28 Meriam St. & 32 Edgewood Rd., 28 Meriam Street Lexington, LLC – Site Plan Review
Public Hearing for special residential development

Date March 7, 2024
To Abby McCabe, Planning Director
From Thomas C. Houston, PE, AICP
Project Application for Major Site Plan Review for
Special Residential Development (Site Sensitive)
28 Meriam Street & 32 Edgewood Road
Lexington, Massachusetts
Subject Peer Review of First Submission to the Planning Board
§

Re: Site Plan Review for 28 Meriam St & 32 Edgewood Rd: Site Sensitive Development (Special Residential Development)

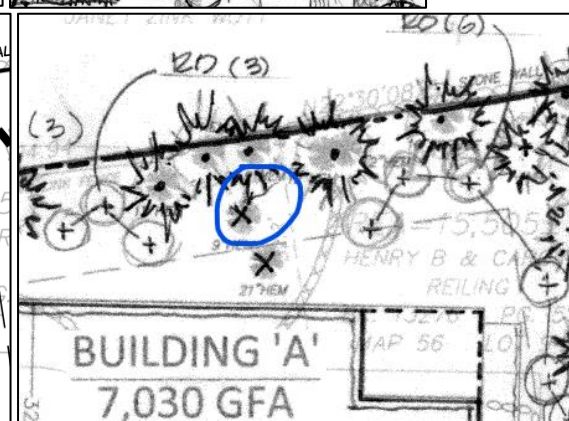
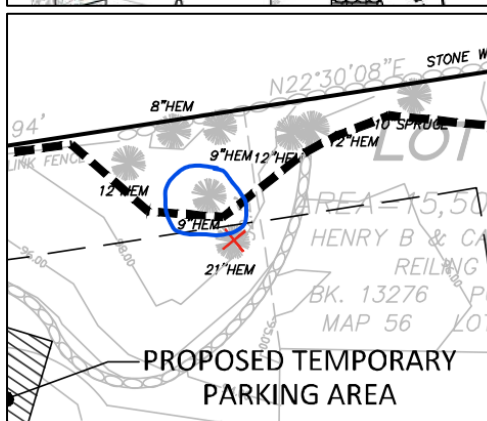
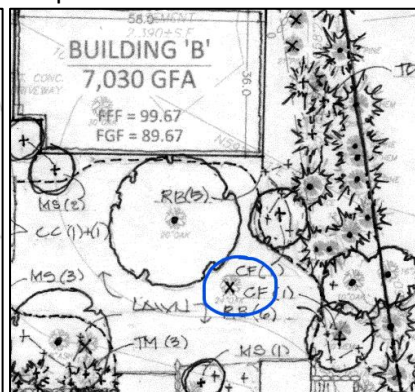
- There should be an internal limit of work line to protect the slope and cluster of preserved trees – roughly draw in the diagram below.

- The images below show the same trees to be protected and removed on different plans.
